STATE OF MARYLAND
CRITICAL AREA COMMISSION
CHESAPEAKE AND ATLANTIC COASTAL BAYS

May 9, 2008

Re: 2008-0061-V – Fiske, David

ADMINISTRATIVE SITE PLAN FOR 212 LONG POINT ROAD

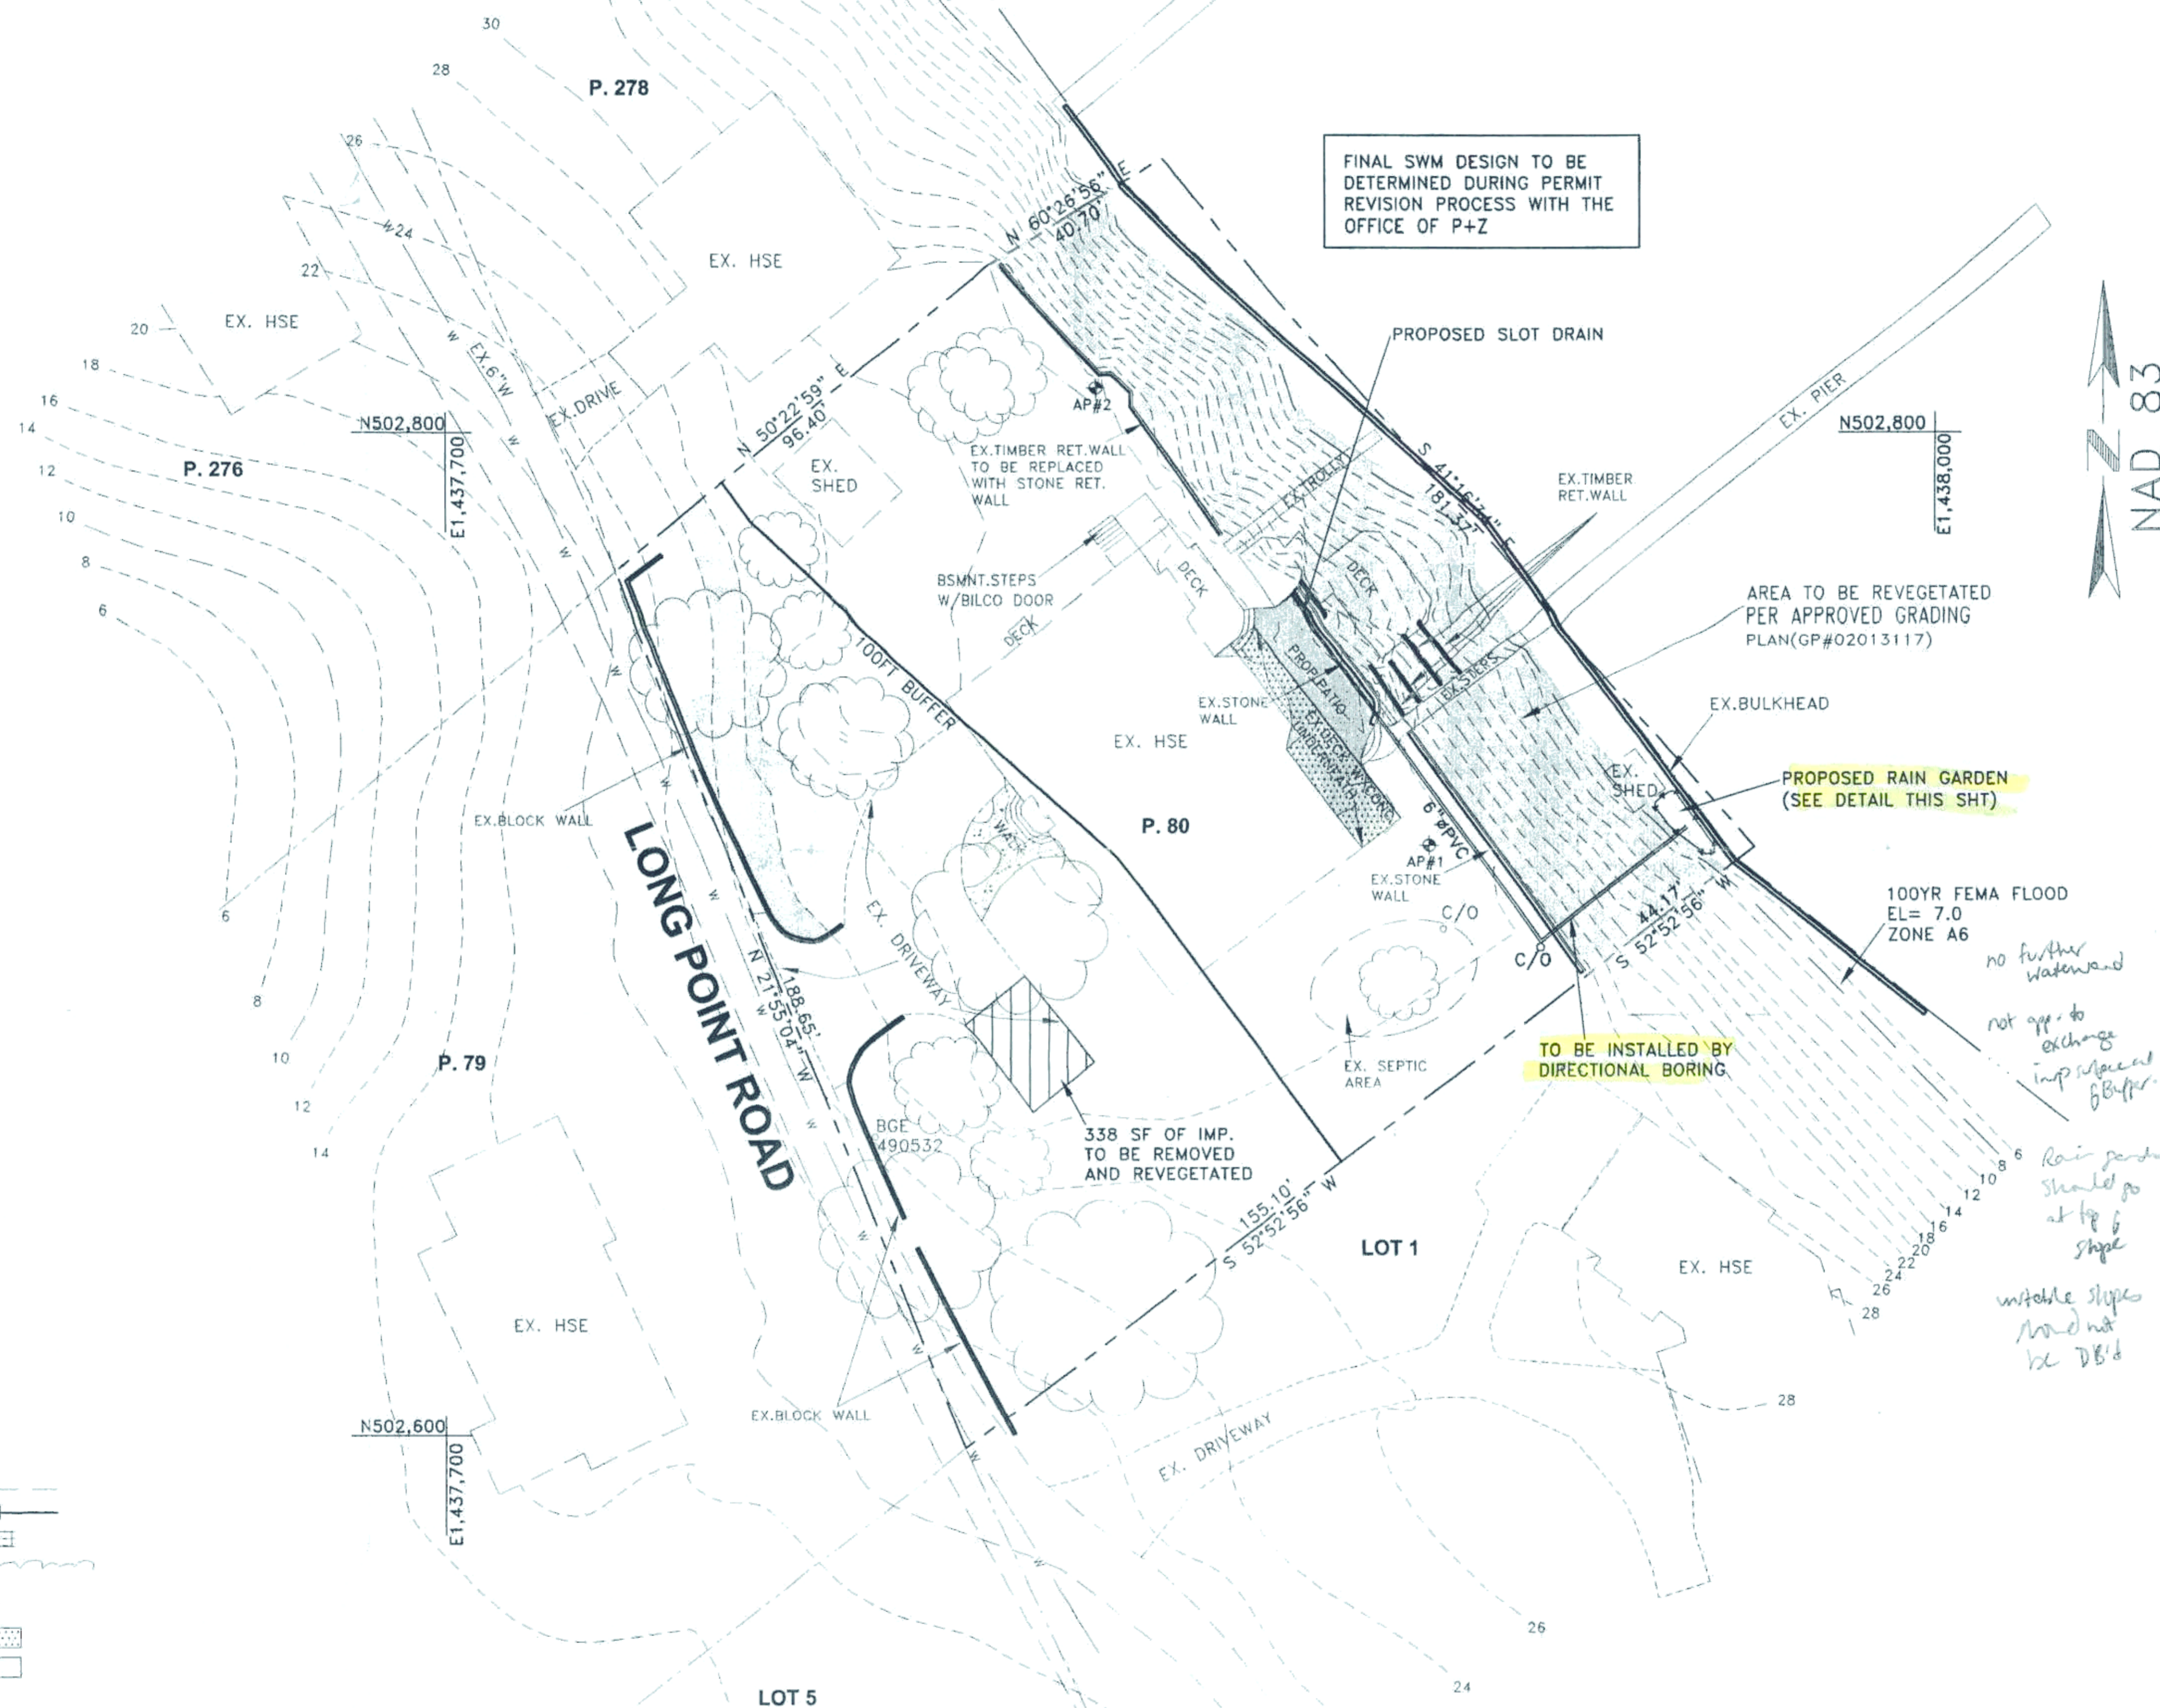
We cannot support the revised variance request as submitted for several reasons. First, the applicant is proposing to remove 338 square feet of impervious surface on the lot to trade off for the increase in impervious surface associated with the proposed patio, which is located waterward of the dwelling and constructed without the proper permits in the Buffer. Provisions for the trading of impervious surface area do not appear to be contained within the County's Zoning Ordinance and should not therefore be considered as a factor in this variance. Further, the proposed area of impervious surface to be removed is located behind the dwelling, outside of the Buffer, while the applicant proposes to retain unpermitted impervious surface within the Buffer, waterward of the dwelling. Second, the applicant is proposing to add a raingarden at the edge of the bulkhead, within the 25-foot Buffer Modification Area (BMA). Generally, BMPs are not permitted in the BMA or in the Buffer, particularly when they can be located in more appropriate locations such as at the top of the slopes on more stable soils. By locating the raingarden as shown on the site plan, the applicant is proposing to directionally bore into erodible on steep slopes which

could contribute to additional erosion and further destabilize these banks. We recommend that runoff from the development be directed to a BMP near the dwelling.

As indicated in my letter of March 11, 2008, we do not oppose the variance request to construct or legalize the retaining walls located in the Buffer. However, we recommend mitigation be required at a 3:1 ratio for this disturbance. The mitigation plantings should be required for the limit of disturbance in the Buffer associated with the retaining walls, including all grading. The full extent of the Buffer Modification Area setback, waterward of the dwelling should be planted with the required mitigation planting. In particular, we recommend that the grassed area between the water and retaining walls be heavily planted and restored so as to provide a functioning Buffer area. The applicant has provided a plantings plan for review by the County. Additionally, appropriate stormwater management techniques should be finalized during the permit revision process with the Office of Planning and Zoning.

We continue to oppose the variance request for the proposed stone patio. The lot is well over the allowable impervious surface amount and the applicant has reasonable outdoor use of the property utilizing the existing concrete patio and multi-level deck, which are situated in the Buffer Modification Area. It does not appear that the standard of unwarranted hardship can be met in regard to the patio. In the case that the construction of this stone patio has been completed, it should be removed and mitigated for at a ratio of 3:1. If this mitigation cannot be done on site, a fee in lieu may be substituted.
